FortisBC Inc. - Okanagan Transmission Reinforcement (OTR) Project

ERRATA 4

Figure 3-6A: Proposed System (Kelowna & Penticton) Capacity Vs Load (WITHOUT SVC)

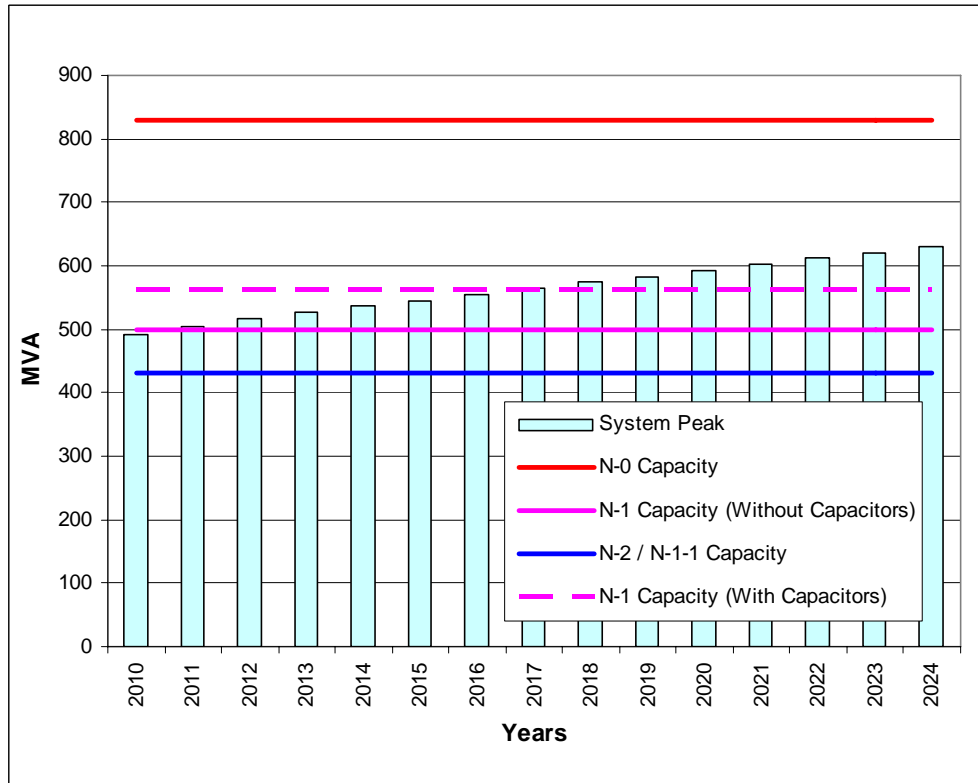
1. **Exhibit B-1 - Section 3, page 37, Figure 3-6A**
Please replace page 37 with the attached updated page 37
For clarity - the figure includes N-1 Capacity (With Capacitors)
2. **Exhibit B-3 - BCUC IR1 response to Q7.2 page 24, line 19**
"I.A.S1" should read "I.A.S3"
3. **Exhibit B-3 - BCUC IR1 response to Q9.4.2, page, Table A9.4.2**
BEN T1 Comments column
"Ex RGA T1" should read "Ex RGA T2"
4. **Exhibit B-3 - BCUC IR1 response to Q10.3, page 56, Table A10.3**
Shaded lines should be 1.2 and 2.2, rather than 1.3 and 2.3
5. **Exhibit B-3 - BCUC IR1 response to Q15.2, page 82, Figure A15.2 Legend**
Please replace page 82 with the attached updated page 82
"N-1 Capacity OTR as in CPCN (Without Capacitors & SVC)" should read "N-1 Capacity OTR as in CPCN (Without Capacitors or SVC)"; and

3 **Figure A15.2**

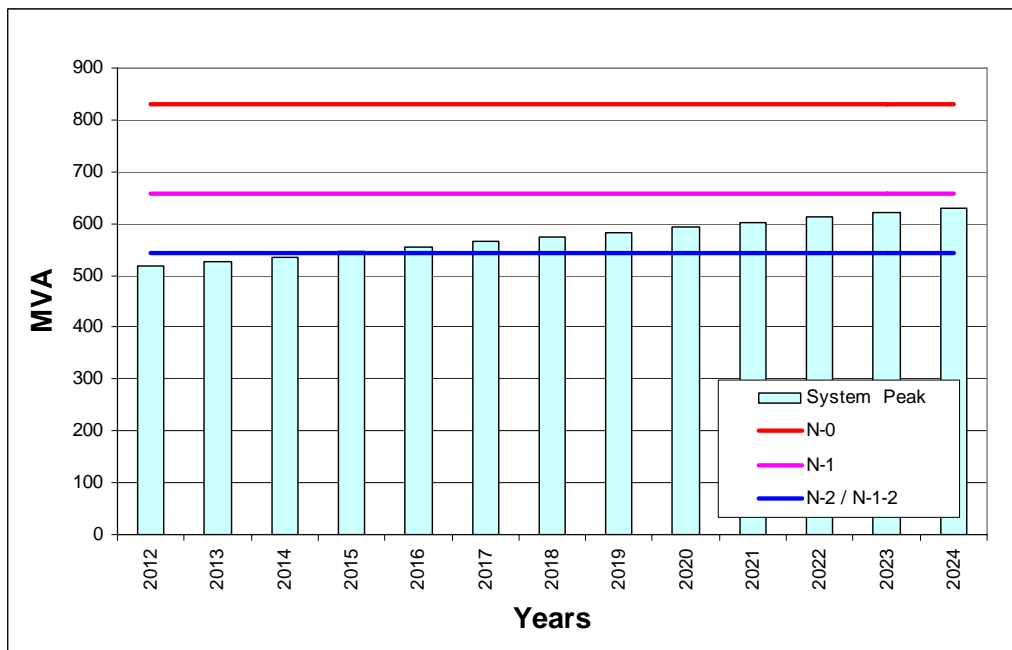
"N-1 Capacity as in CPCN (With Capacitors & SVC)" should read "N-1 Capacity as in CPCN (With Capacitors & without SVC)"
6. **Exhibit B-3 - BCUC IR1 response to Q41.2**
line 6 - "Q47.2" should read "Q45.4"
line 8 - "Q44.4" should read "Q45.4"
7. **Exhibit B-8 - SOFAR/Wiltse IR1 response to Q15.2, pages 23-24**
To supplement this response, the information given previously does not take into account the final costs associated with delay for land availability or any of the non-financial costs associated with the Upland route, which would have application here for the diversion corridor and a portion of the Upland route.
8. **Exhibit B-11 - SOFAR IR2 response to Q20.1, page 6, line 17**
"2.0" should read "2.5"
